SUBJECT: ADDENDUM #1

Date: October 27, 2026

Project: Site Work, Restroom & Fire Alarm Upgrades at Quail Valley Middle School
Snowline Joint Unified School District
FFJ Project No: SJ21-01
DSA File No.: 36-73 DSA Appl. No: 04-121057

NOTE:
1. PROVIDE NEW WALL & FLOOR TILE IN RESTROOMS, SEE FINISH SCHEDULE. PREP EXISTING WALLS TO RECEIVE NEW FINISH.
2. DETAIL AT ADJACENT ROOMS NOT SHOWN FOR CLARITY. ⚠1

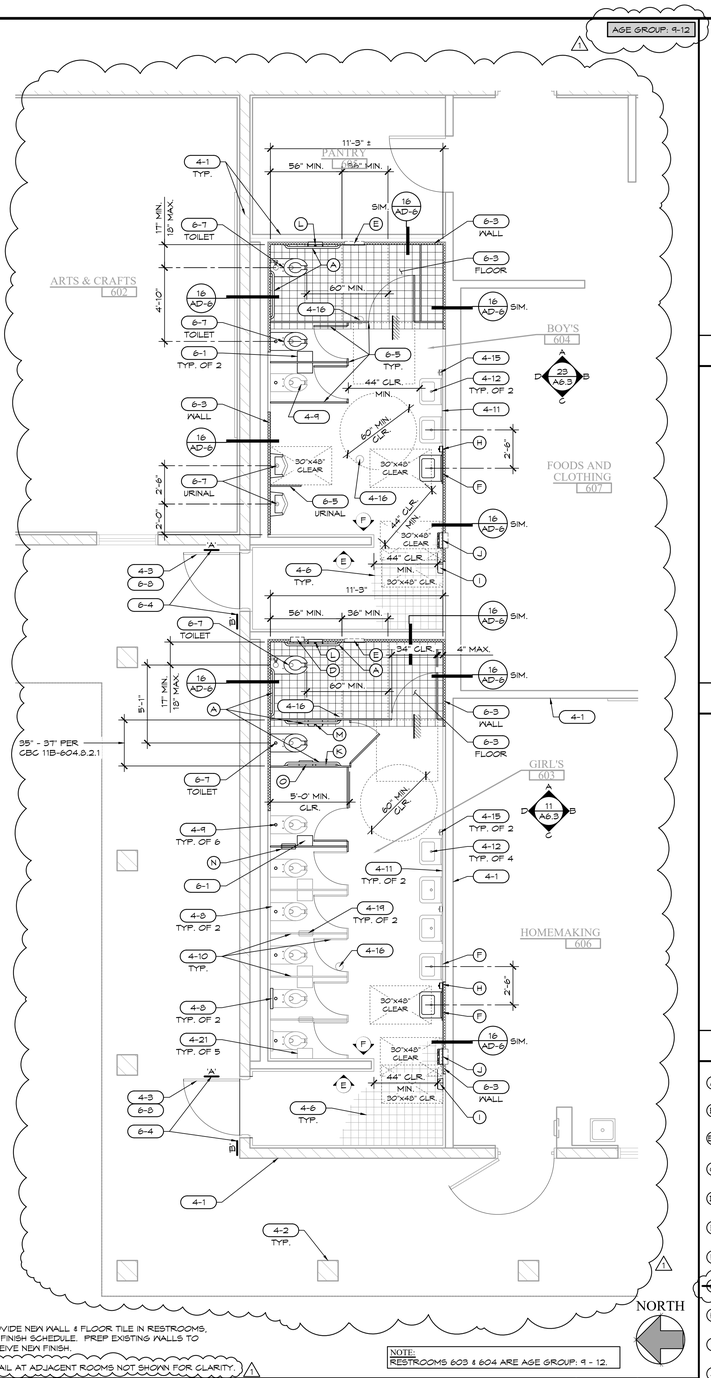
b. Detail 23:
1. Various keynotes for new and existing added to clarify scope of work to be done.
2. Hatch added to walls where new finish to be added for construction purposes.
